**Proposal #35: 8725-02-70, WIS 2021 191
Benoit – STH 112
USH 63 to STH 112
STH 118
Bayfield & Ashland Counties**

This is Addendum No. 1, which provides for the following:

ADDENDUM NO. 1

Figure 1: Nuclear/Core Correlation Location Layout

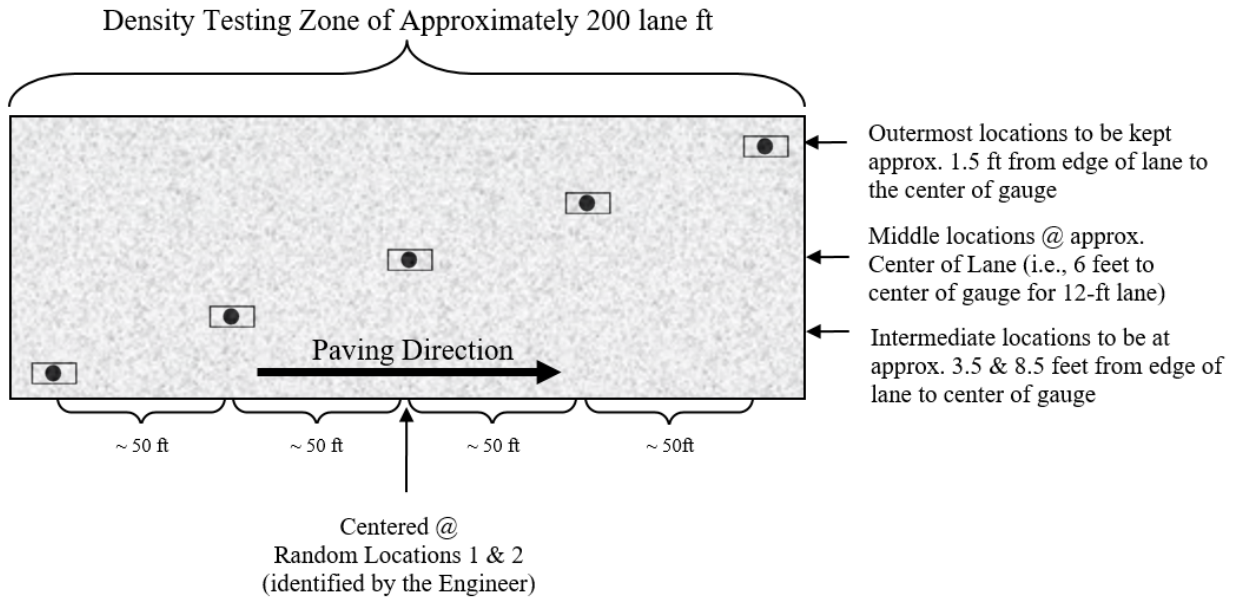
The engineer will identify two zones in which gauge/core correlation is to be performed. These two zones will be randomly selected within each *half* of the test strip length. (Note: Density zones shall not overlap and must have a minimum of 100 feet between the two zones; therefore, random numbers may be shifted (evenly) in order to meet these criteria.) Each zone shall consist of five locations across the mat as identified in Figure 1. The following shall be determined at each of the five locations within both zones:

Each core 150 mm (6 inches) in diameter will be taken at locations as identified in Figure 1. Each random core will be full thickness of the layer being placed. The contractor is responsible for thoroughly drying cores obtained from the mat in accordance with ASTM D 7227 prior to using specimens for in-place density determination in accordance with AASHTO T 166 as modified by CMM 8-36.6.5.

Figure 4: Locations of main lane HMA density testing (QC=solid lines, QV=dashed)

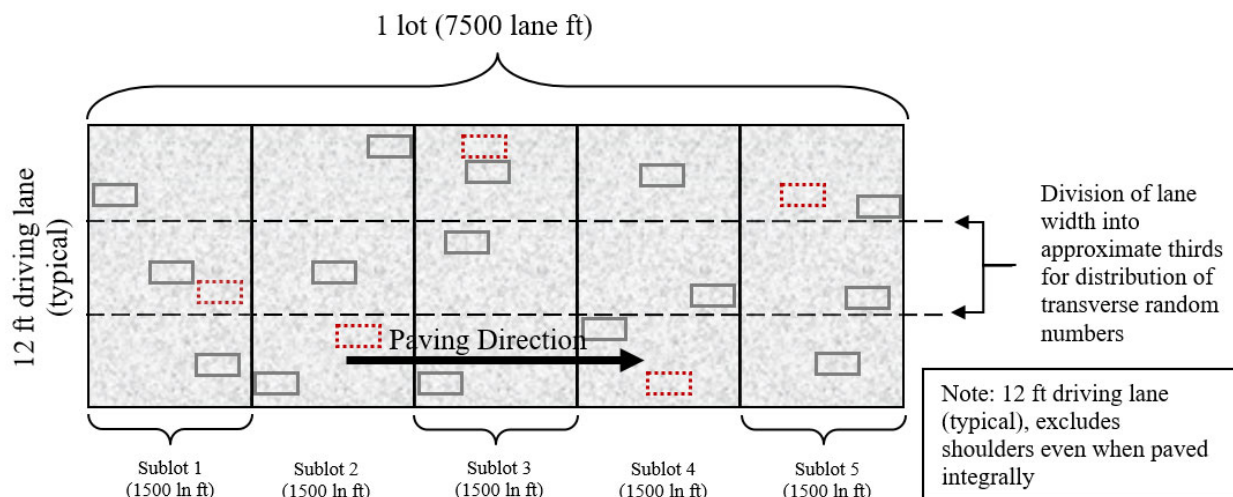
For nuclear density testing of the pavement beyond the test strip, QC tests will be completed at three locations per subplot, with a subplot defined as 1500 lane feet. The three locations will represent the outside, middle, and inside of the paving lane (i.e., the lane width will be divided into thirds as shown by the dashed longitudinal lines in Figure 3 and random numbers will be used to identify the specific transverse location within each third in accordance with CMM 8-15). Longitudinal locations within each subplot shall be determined with 3 independent random numbers. The PWL Density measurements do not include the shoulder and other appurtenances. Such areas are tested by the department and are not eligible for density incentive or disincentive. Each location will be measured with two one-minute gauge readings oriented 180 degrees from one another, in the same footprint as detailed in Figure 2 above. Each location requires a minimum of two readings per gauge. The density gauge orientation for the first test will be with the source rod towards the direction of paving. QV nuclear testing will consist of one randomly selected location per subplot. The QV is also comprised of two one-minute readings oriented 180 degrees from one another. For both QC and QV test locations, if the two readings exceed 1.0 pcf of one another, a third reading is conducted in the same orientation as the first reading. In this event, all three readings are averaged, the individual test reading of the three which falls farthest from the average value is discarded, and the average of the remaining two values is used to represent the location for the gauge. The subplot density testing layout is depicted in Figure 4, with QC test locations shown as solid lines and QV as dashed.

WisDOT Longitudinal Joint – Nuclear Gauge Density Layout

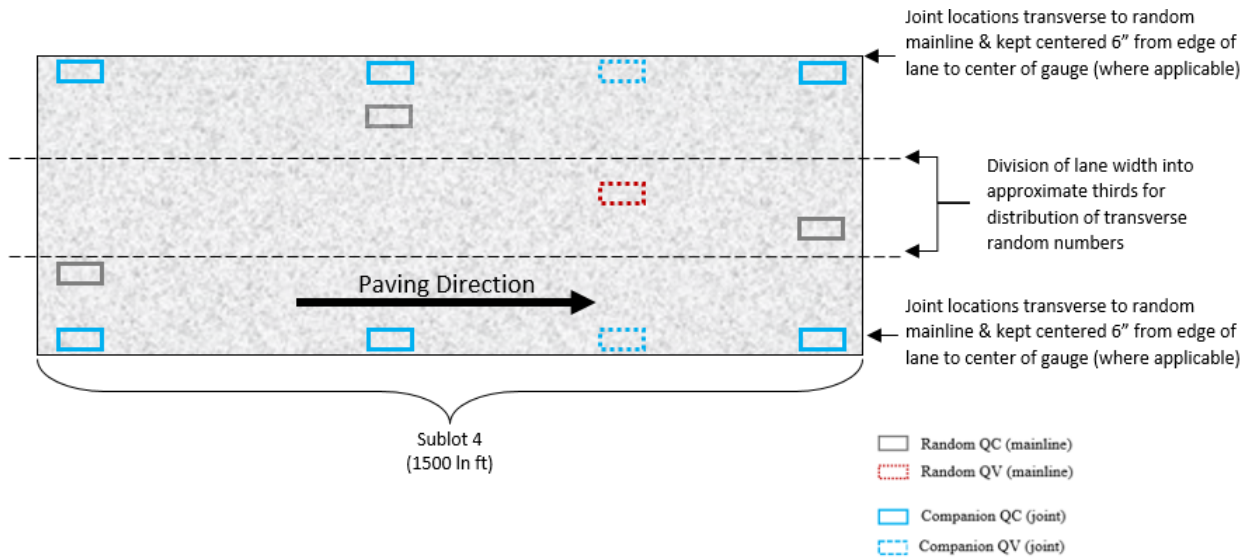
Each QC and QV density location must have a companion density location at any applicable joint. This companion location must share longitudinal stationing with each QC or QV density location and be located transversely with the center of the gauge 6-inches from the edge of the paving area.
